CLASS II PERMISSIVE CHANGE REQUEST

RE: Class II Permissive Change Request
FCC ID: 2AEHI-EP0121

Applicant	Equipment	Product Name	FCC ID
Chiaro Technology Ltd	EP01	Elvie Pump	2AEHI-EP0121

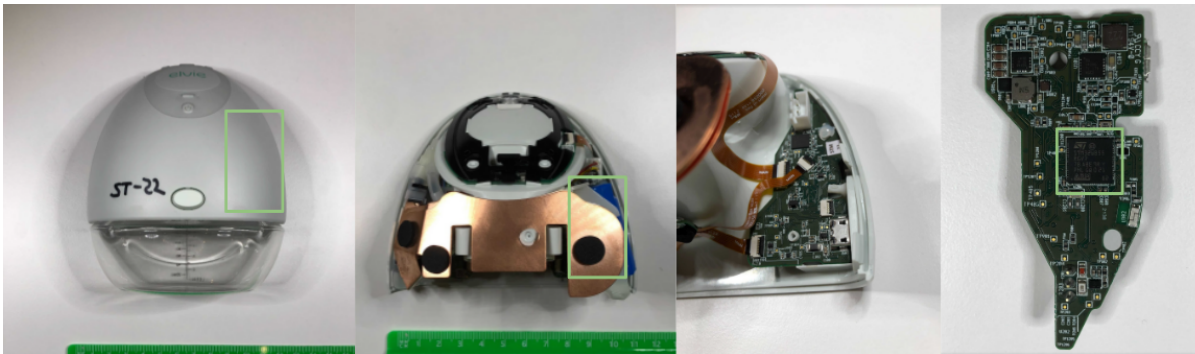
The MCU is an integrated Bluetooth Low Energy SoC that is offered in a number of different footprint options. The below picture shows the location of the MCU.

We are proposing to change the footprint from the **STM32WB55RGV6TR in a VFQFPN68 package** to an **STM32WB55VG6TR in a WLCSP100 0.4 mm pitch package**. The internal silicon die will remain the same but in a different external package.

Figure 42. WLCSP100 recommended footprint

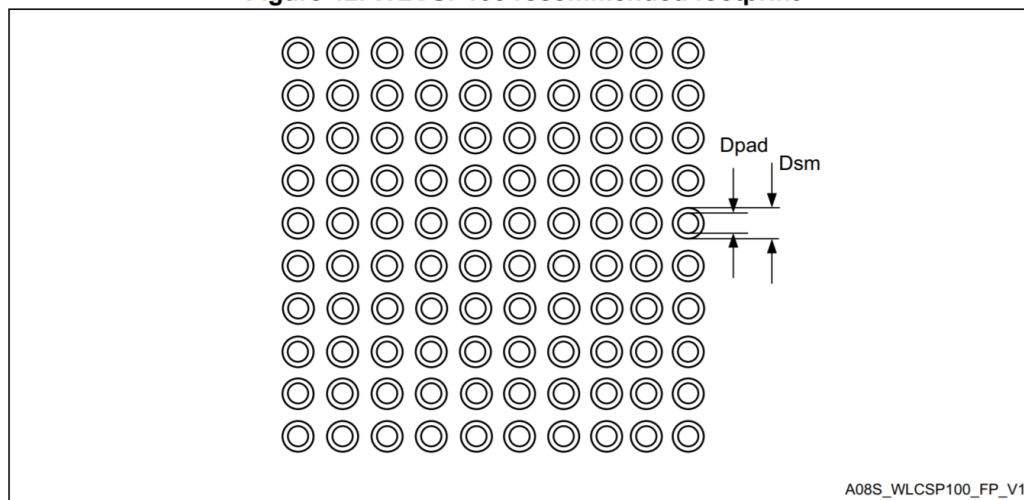
- There will be a slight change to the PCB layer stack to accommodate footprint change.
- The layer count remains unchanged
- The layer separation distances will be modified to accommodate a new footprint routing
- The PCB traces local to the MCU SoC will be modified to accommodate the new footprint as per the guidance images below

Dimension	Recommended values
Pitch	0.4 mm
Dpad	0.225 mm
Dsm	0.290 mm typ. (depends on the soldermask registration tolerance)
Stencil opening	0.250 mm
Stencil thickness	0.100 mm

3.1 Bottom Channel Current Design

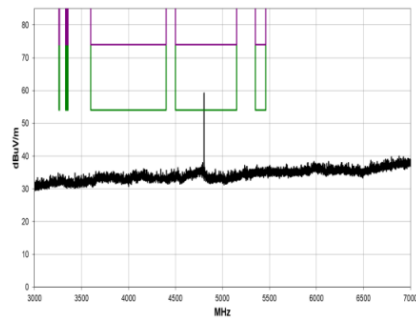
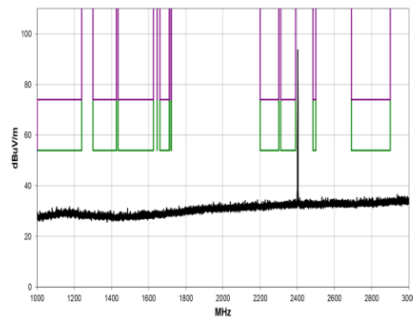
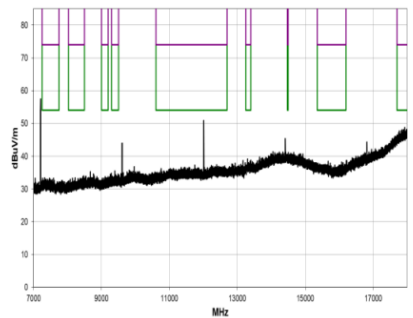
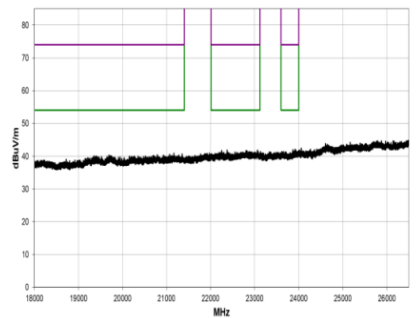
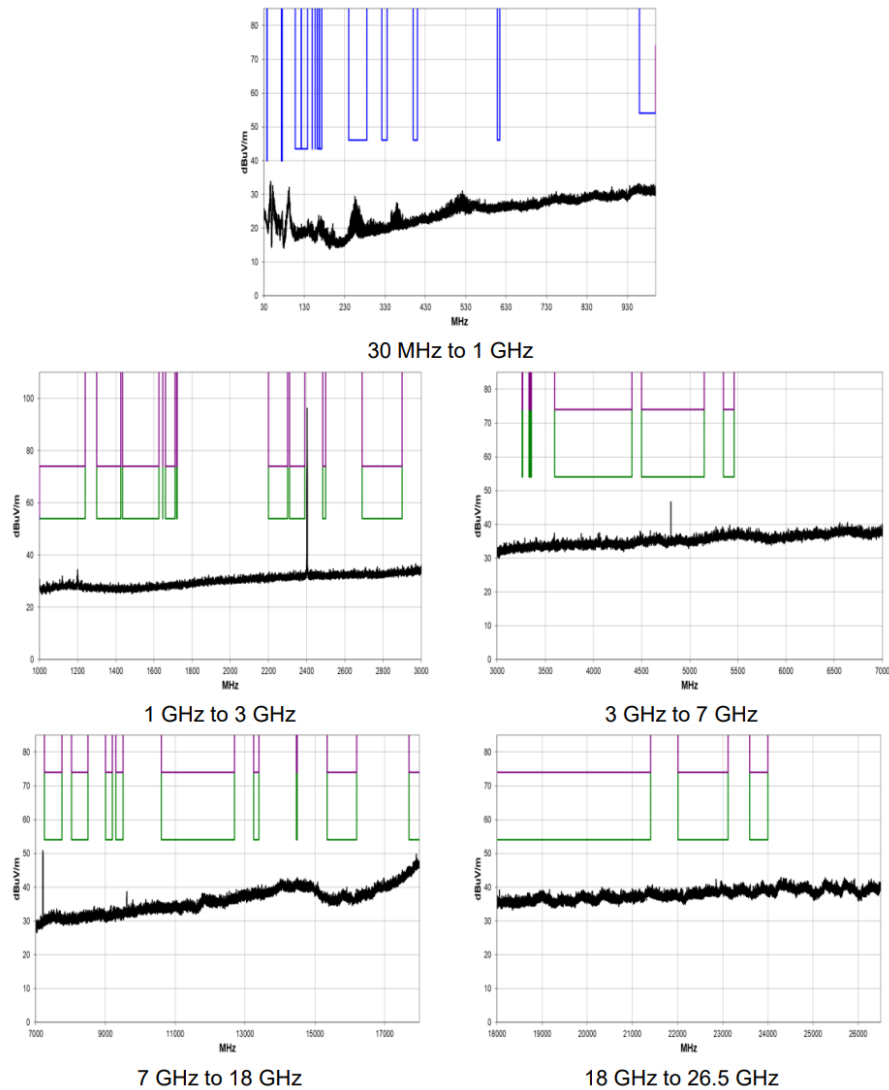
Test data has shown that the change of the main MCU IC package has made negligible impact to RF performance. Radio test results shown above show minimal deviations from the original test results along with all results shown for the new design still being within the defined limits. Given that the proposed change is for an electrically identical SoC with the same internal silicon, just in a different package we believe this replacement can be described as 'variation in electrical or mechanical construction' as described in 47 CFR 2.1043

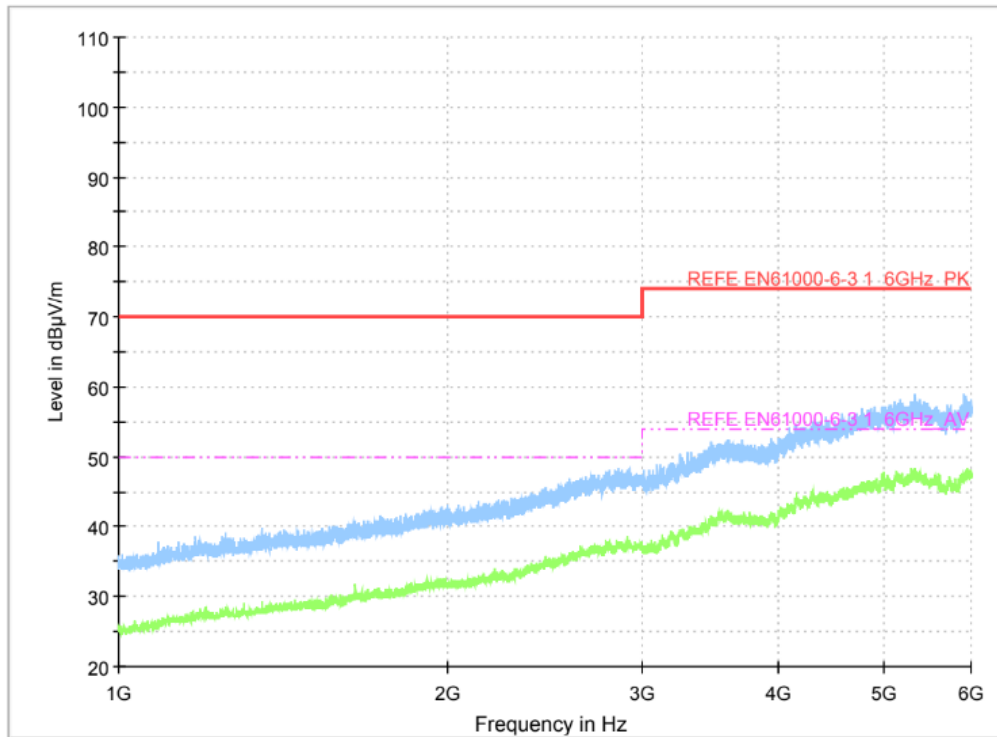
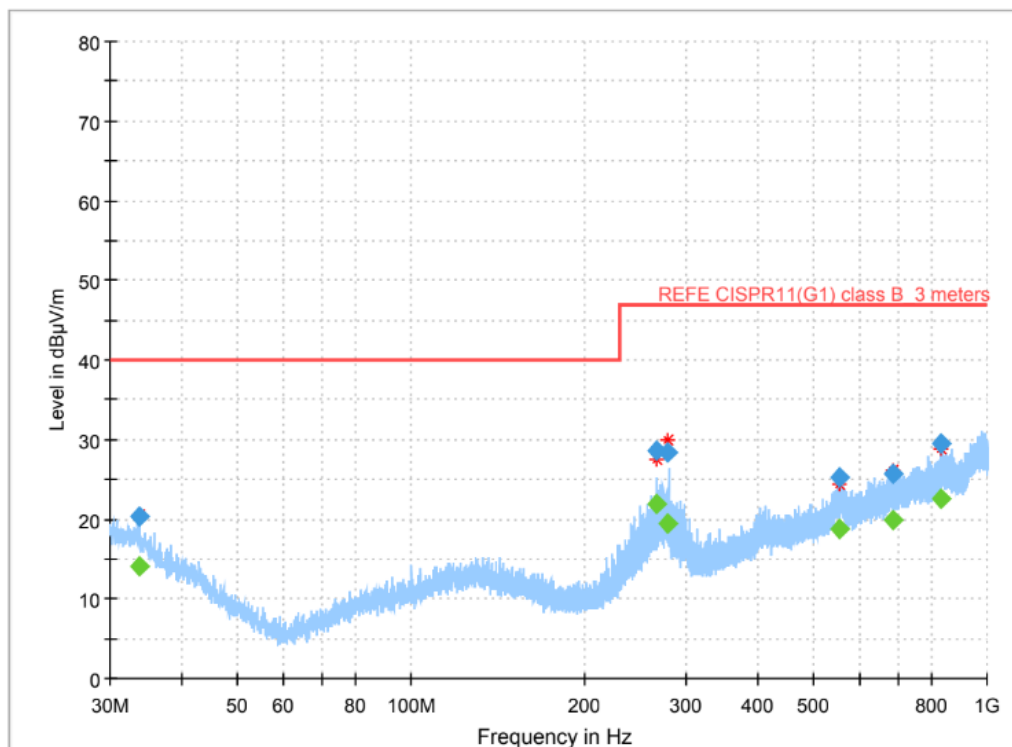
Preliminary EMC test results of the new design are also within limits

REFE Above 1G Pass

REFE Below 1G pass
